Z-30
(2010)

DATE: 7/20/10
 TFFANY PLACE UNIT III
 COBB COUNTY, GEORGIA
 LAND LOT: 29
 DISTRICT: 1ST
 PROJECT: CO-103

SHEET:
REZONING PLAN

PETITION NO: Z-30

REZONING PLAN
 AUG 5 2010
 COBB CO. COMM. DEV. AGENCY
 ZONING DIVISION

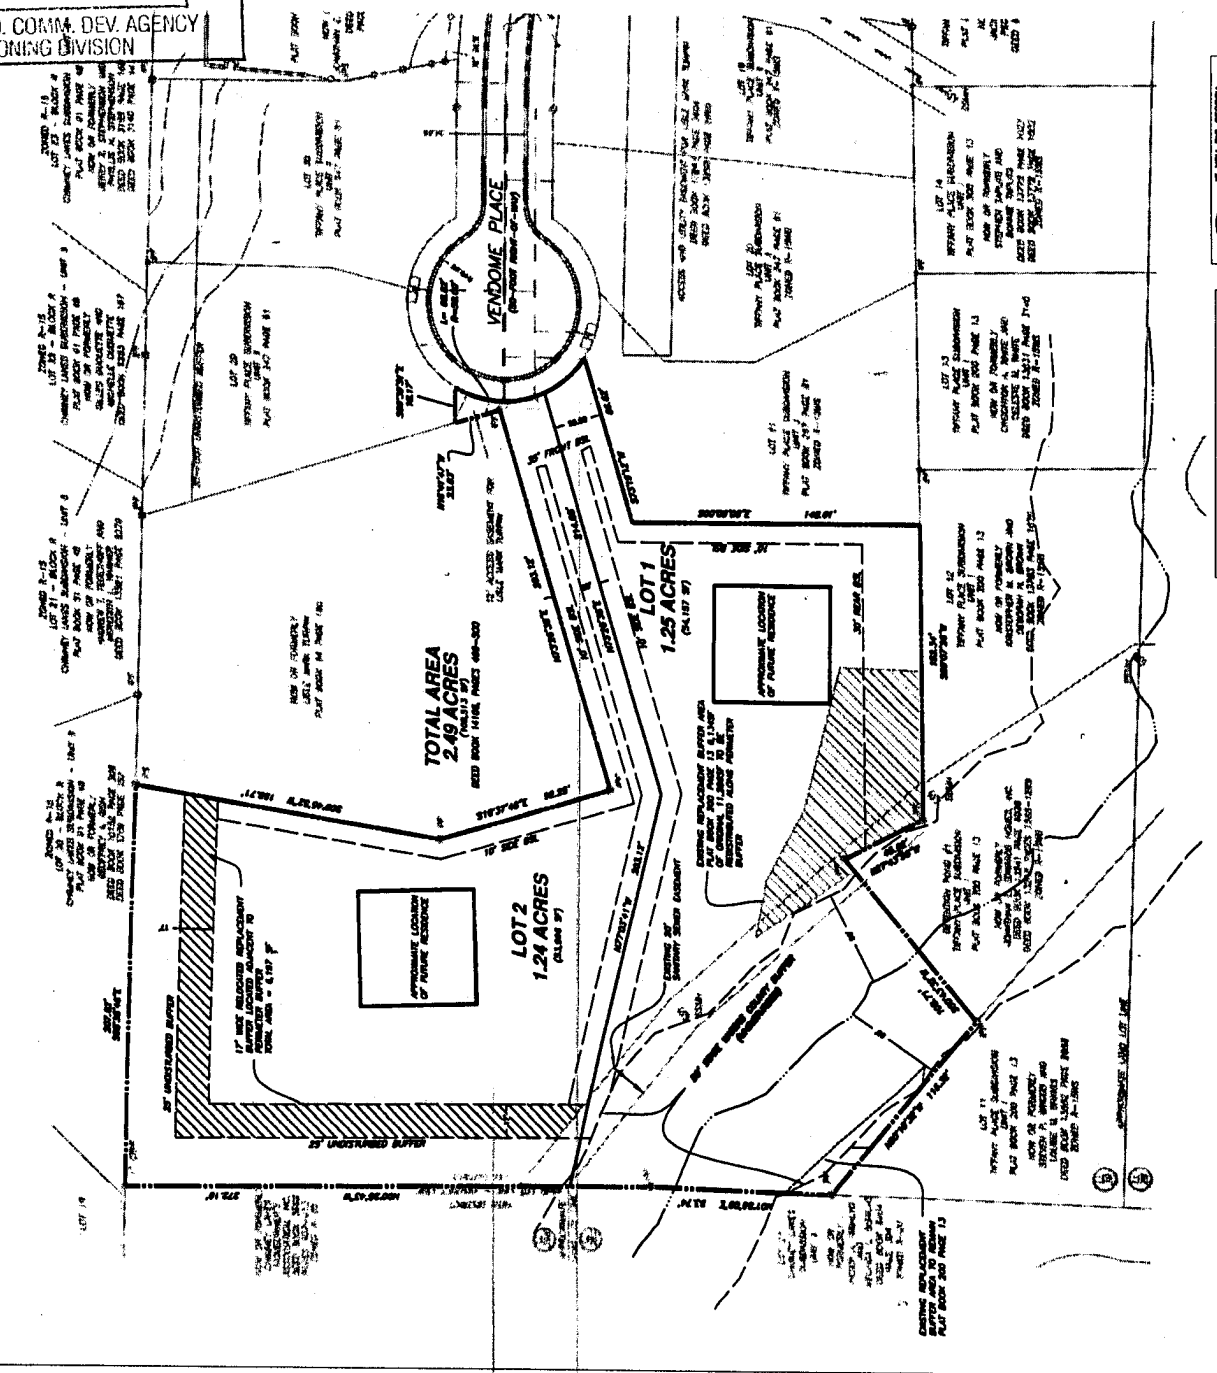
Both of these proposed lots are located on steep slopes ranging from 17 to 28%. A site grading plan should be submitted to the Stormwater Management Division prior to permitting to verify that grading does not encroach into undisturbed buffer areas and that no concentrated discharge points are created.

Additional Comments: Meters to be set at Vendome Place ROW

Additional Both lots must connect to sewer
Comments:

Shared drive for lots fronting Vendome Place.

Recommend shared driveway access.

- Site plan received by the Zoning Division on August 5, 2010;
- 42-foot undisturbed buffer along northern and western property line;
- Water and Sewer comments and recommendations;
- Stormwater Management comments and recommendations; and
- DOT comments and recommendations.
